Access Compliance Report

Public Rights-of-Way

(Pedestrian Signals)

Intersection ID: N/A	Main Street:	Cross Street: N/A	Location: N/A
ADA ID: F8F46327B2B5	Signal Type: One Push Button-Non APS	Overall Compliance: No	Severity Score: BTN 1: N/A BTN 2: N/A No BTN: N/A
Codes/Mitigation Info/Possible Solution		Field Measurements/Component Compliance

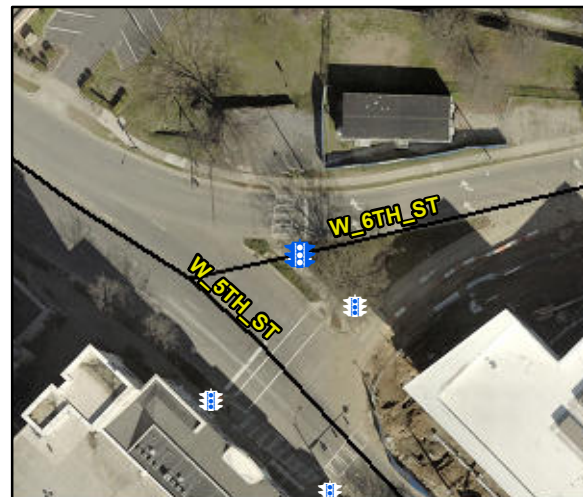
Surveyor Notes: TEXT HT 1/4, DIST BETWEEN ADDL BUTTON 502.0

PROW/ADA: R410.6, TMUTCD 4e.08, R404.2, R404.3, R406.2

Possible Solutions: Replace Signal Push Button With APS Button on New Post. Remove & Replace Sign.
